Subject: AP1000 COL Standard Technical Report Submittal of APP-GW-GLN-121, Revision 0

APP-GW-GLN-121, Revision 0
“Spent Fuel Pool Water Level and Dose”

This Technical Report increases the normal Spent Fuel Pool (SFP) water level from 133.25 ft to 134.25 ft. The change in water level limits exposure rates to personnel on the Spent Fuel Pool Fuel Handling Machine to less than or equal to 2.5 millirem per hour.

Attachment 1 – Schematic of DCD Tier 1, Table 2.1.1-1, ITAAC Requirement

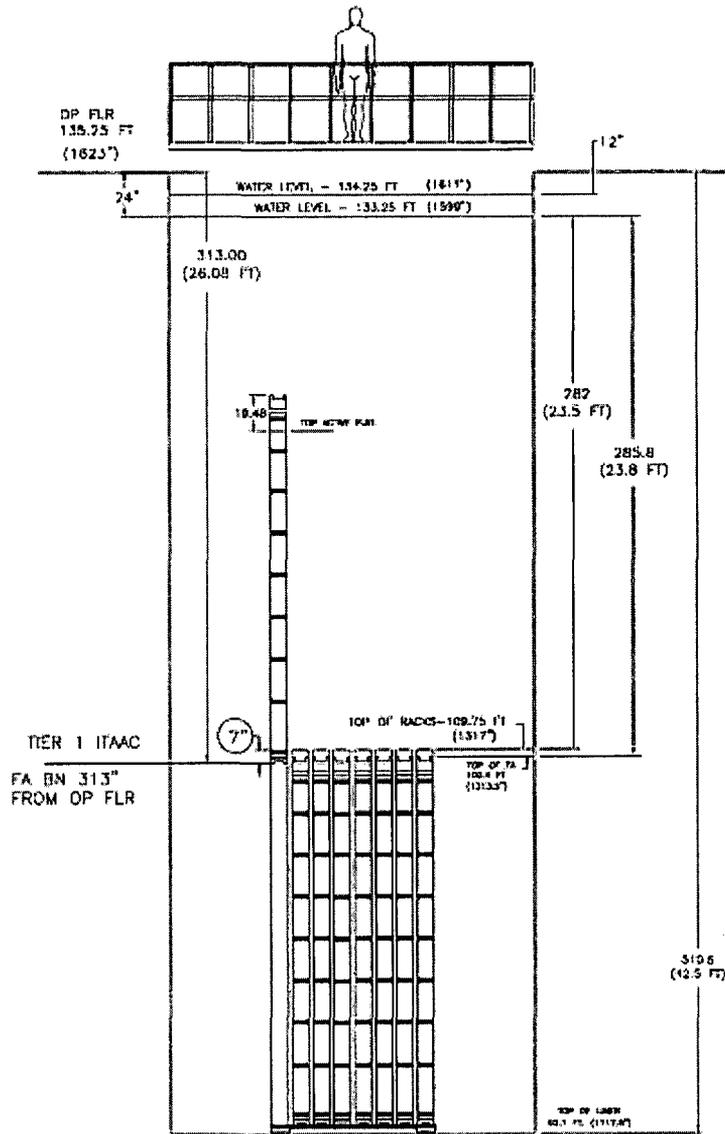
As shown in Attachment 1 - Schematic of DCD Tier 1, Table 2.1.1-1, ITAAC Requirement, this DCD section specifies a FHM lift height acceptance criteria that the bottom of the fuel assembly cannot be raised to within 26 ft, 1 inch (313 inches) of the operating deck floor. Based on the AP1000 SFP design, the fuel assembly bottom nozzle is 7 inches inside the storage rack cell at 313 inches from the operating deck floor. This criterion will not allow the fuel assembly to be fully withdrawn from the storage racks. Therefore, the acceptance criteria is changed as noted in the markup of Table 2.1.1-1 below.

5. The lift height of the RM and FHM masts is limited such that the minimum required depth of water shielding is maintained.	The RM and FHM will be tested by attempting to raise a dummy fuel assembly.	The bottom of the dummy fuel assembly cannot be raised to within 26 ft, 1 in 25 ft, 3 in of the operating deck floor.
--	---	--

Attachment 3 – Schematic of New SFP Fuel Water Coverage Conditions

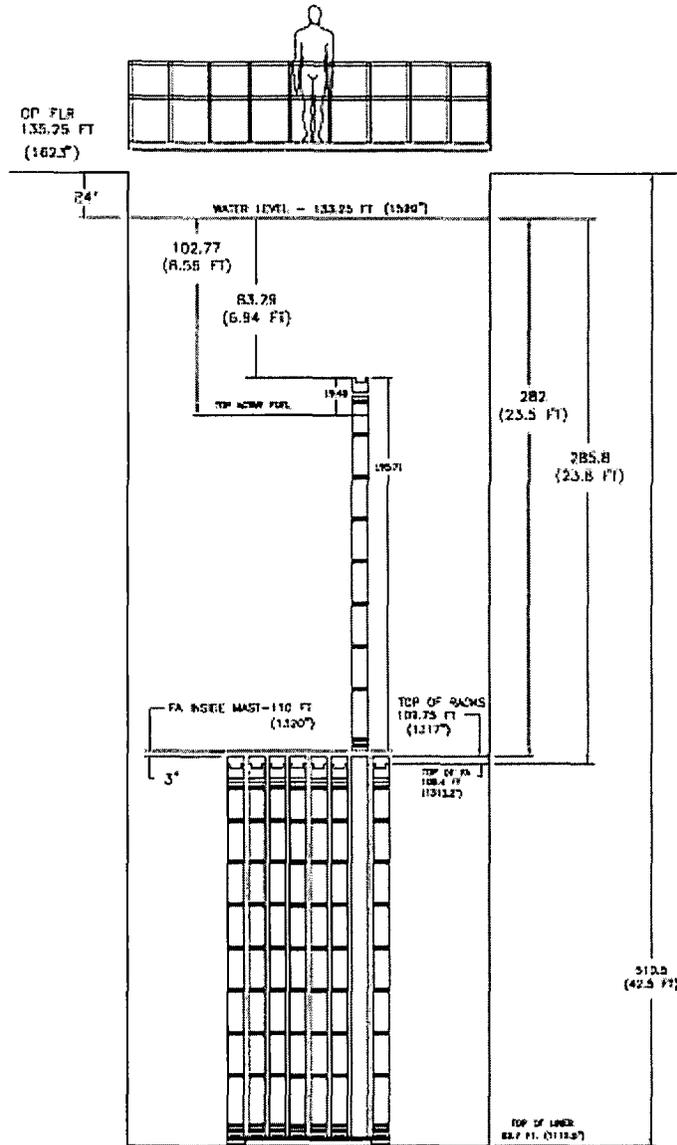
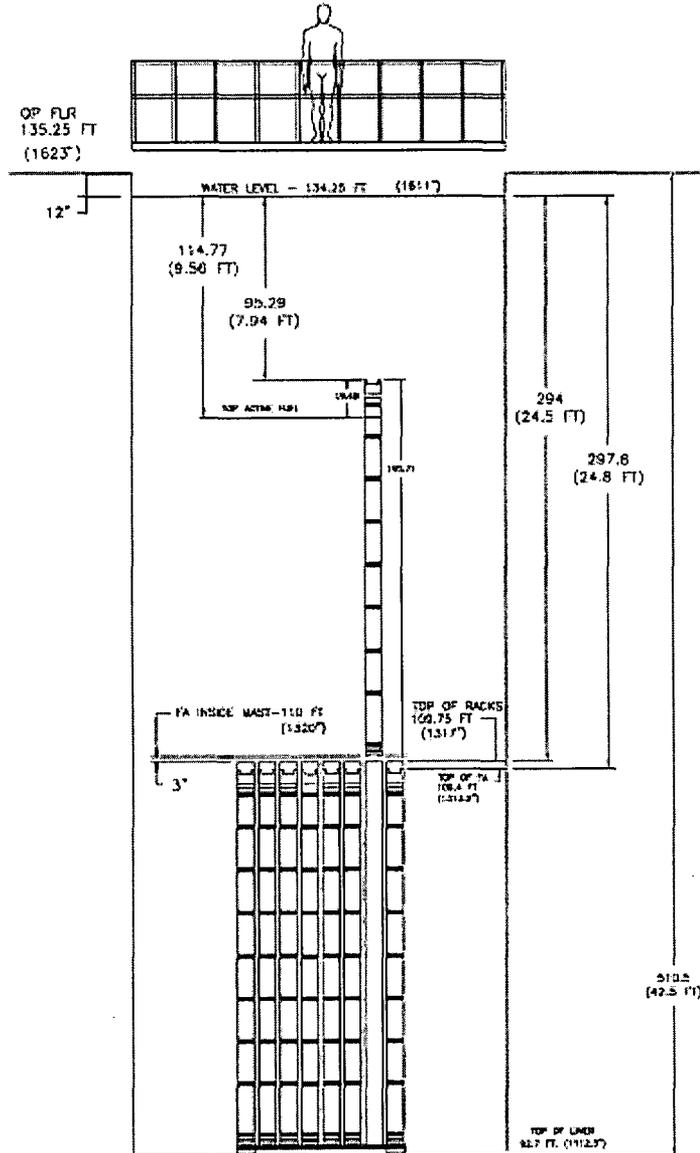
This Technical Report increases the normal SFP water level from 133.25 ft to 134.25 ft (See Attachment 3).

Attachment 4 – Radiation Dose Rates – 108.77” Water Coverage

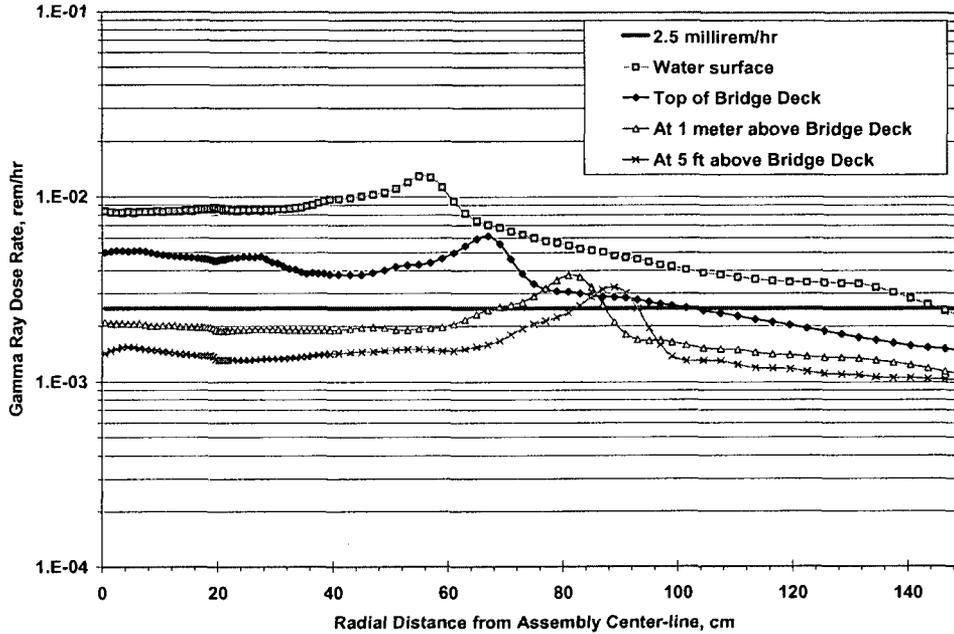
This change limits exposure rates to personnel on the Spent Fuel Pool Fuel Handling Machine to 2.5 millirem or less as shown in Attachment 5. Attachment 4 is included to show that raising the water level 6" is insufficient to provide the proper shielding.
